UNITED STATES PATENT AND TRADEMARK OFFICE

APPLICATION NO.	FILING DATE	FIRST NAMED INVENTOR	ATTORNEY DOCKET NO.	CONFIRMATION NO.
10/763,961	01/23/2004	Jens Beger	HOE-593.1	7911
20028	7590	06/26/2006		
Lipsitz & McAllister, LLC 755 MAIN STREET MONROE, CT 06468			EXAMINER RAMANA, ANURADHA	
			ART UNIT 3733	PAPER NUMBER

Office Action Summary	Application No. 10/763,961	Applicant(s) BEGER ET AL.	
	Examiner Anu Ramana	Art Unit 3733

DETAILED ACTION

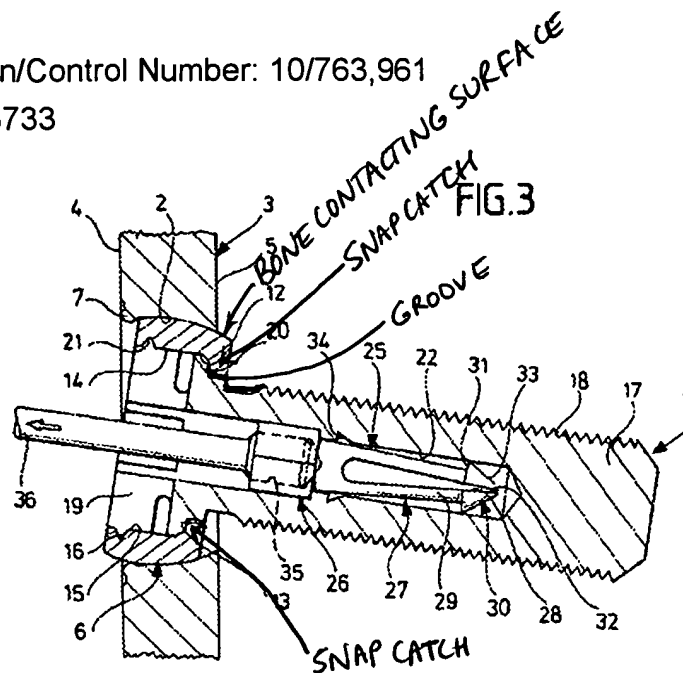
Applicants' further argue that the Eckhof et al. clamping element 6 does not have snap catches protruding from a bone contacting surface. This is not found to be persuasive as shown in marked up Figure 3 on the following page.

Further, snap catches of clamping element 6 engage a circumferential groove or "furrow" below the screw head as shown in marked up Figure 3 above.

Eckhof et al. also disclose placement of the bone screw through the clamping element 16 wherein engagement of "snap catches" 20 in a groove below the screw head limits the insertion depth of the screw.
